Contract #: 04-0120F4Cty: SF/ALA Rte: 80 PM: 13.2/13.9File #: 69.25B**QUALITY ASSURANCE -- NON-CONFORMANCE REPORT****Location:** Changxing Island, Shanghai, P.R. China**Report No:** NCR-000407**Prime Contractor:** American Bridge/Fluor Enterprises, a JV**Date:** 30-Aug-2009**Submitting Contractor:** Zhenhua Port Machinery Company, Ltd (ZPMC), Changxing Island**NCR #:** ZPMC-0381**Type of problem:****Welding****Concrete****Other****Welding****Curing****Procedural****Bridge No:** 34-0006**Joint fit-up****Coating****Other****Component:** Crossbeam 14**Procedural****Procedural****Description:****Reference Description:** Heat Straightening without Engineer's Approval on CB10**Description of Non-Conformance:**

NON-CONFORMANCE REPORT TRANSMITTAL

Job Name: SAS Superstructure

Subject: NCR No. ZPMC-0381

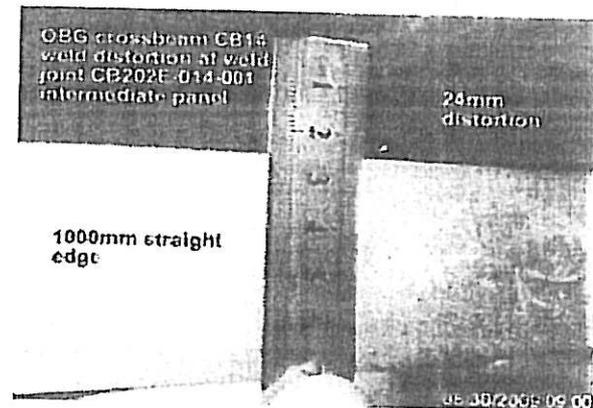
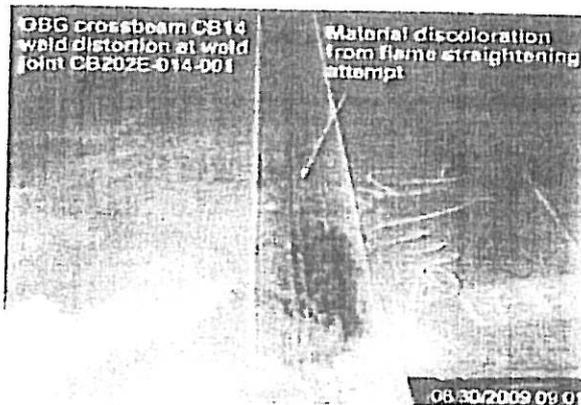
The Quality Assurance Inspector (QA) observed the contractor performing heat straightening on 15mm material without the Engineer's approval. The procedure presented to the QA inspector on the shop floor (HSR1(B)-7358) indicated that the distortion was 5mm. The QA inspector measured the distortion at 24mm in 1000mm. The weld joint is identified as CB202E-014-001.

Contract Special Provisions 8-3.01 "for material equal to or less than 16mm, the contractor shall not heat straighten members more than 6 in 1000 without prior approval of the Engineer".
